APPLICATION FOR PERMISSION UNDER SECTION 16 OF THE TOWN PLANNING ORDINANCE (CAP.131)

TPB/A/YL-SK/338

元朗八鄉蓮花地村丈量約份第 112 約地段第 721 號餘段 (部分)
臨時私人停車場 (只限私家車) (為期 3 年)
(第 16 條規劃申請編號: A/YL-SK/338)

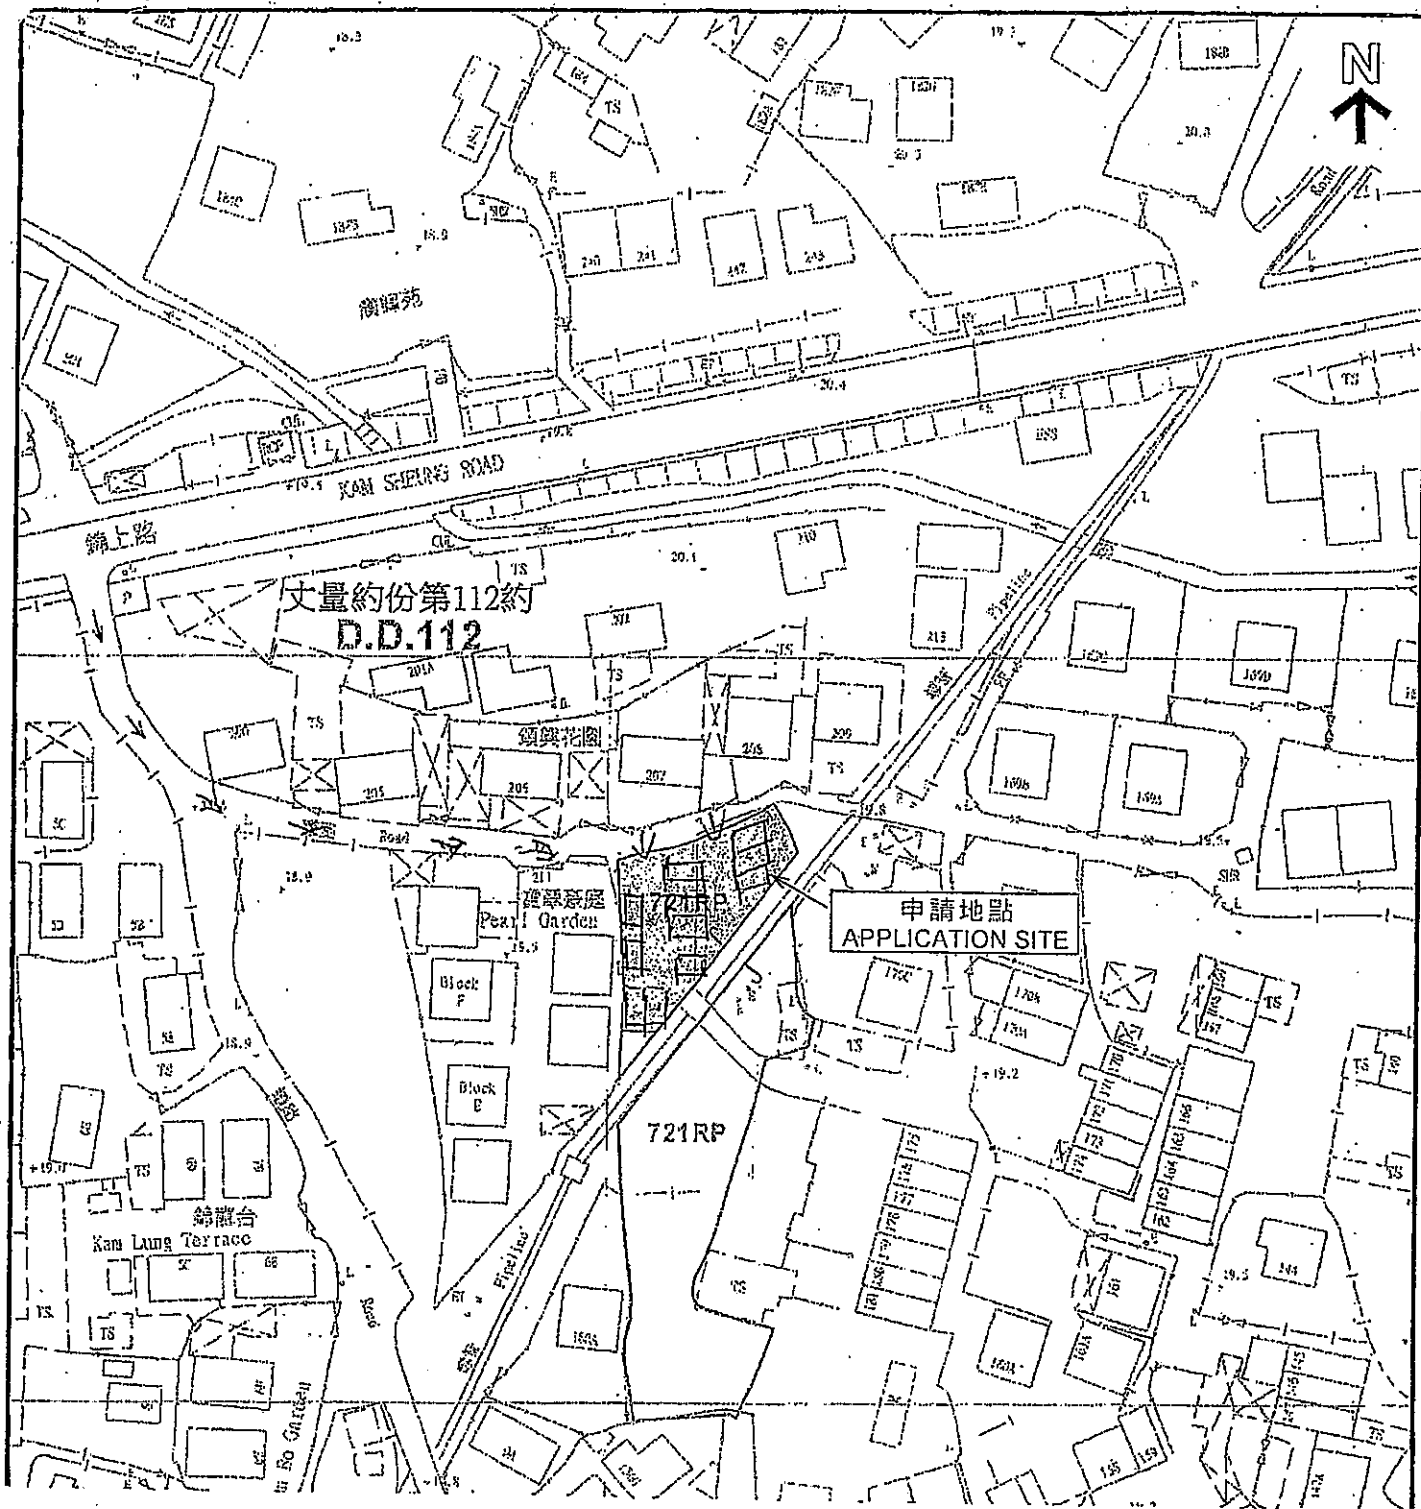
- The applicant should indicate the clear width of the vehicular ingress / egress on the layout plan.
